PRODUCT / PROCESS CHANGE INFORMATION

1.1 Company	 STMicroelectronics International N.V
1.2 PCI No.	ADG/23/13891
1.3 Title of PCI	Full Chisel Carrier Tape for TQFP 20x20x1.4 Packages (Malta Plant)
1.4 Product Category	see list
1.5 Issue date	2023-04-06

TQFP 20x20x1.4 Full Chisel Carrier Tape Change

20x20x1.4 Full Chisel Design Carrier Tapes - PEAK

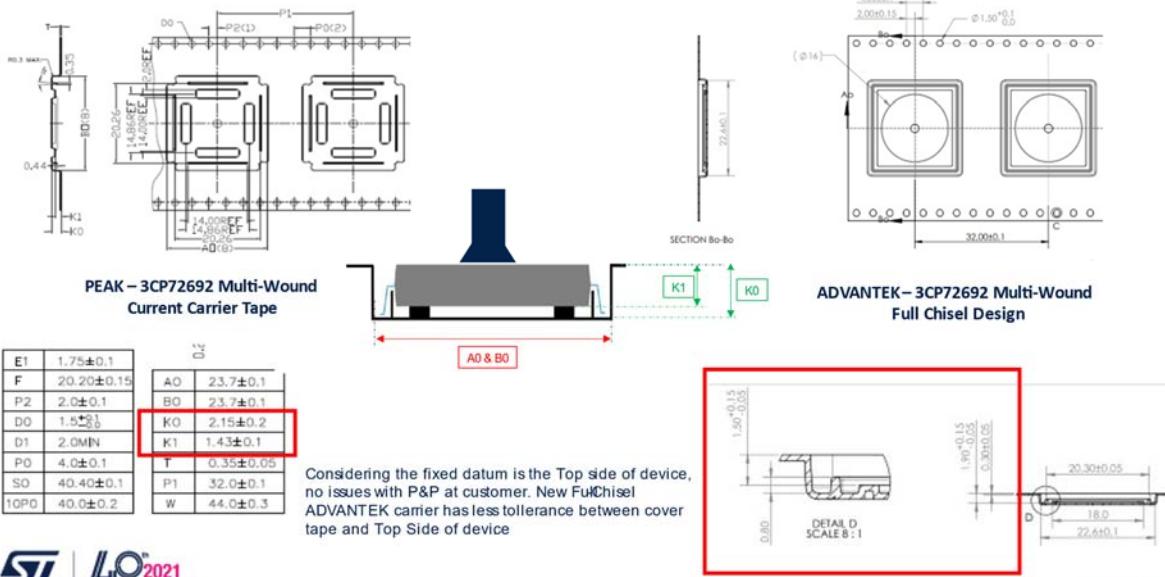
Additional suppliers qualification for TQFP 20x20x1.4 **Full Chisel** Carrier Tape. This affected ST MALTA.

New : PEAK (ST material code reference: 3CP72692)
 ADVANTEK (ST material code reference: 3CP72692)
 CPAK (ST material code reference: 3CP72692)
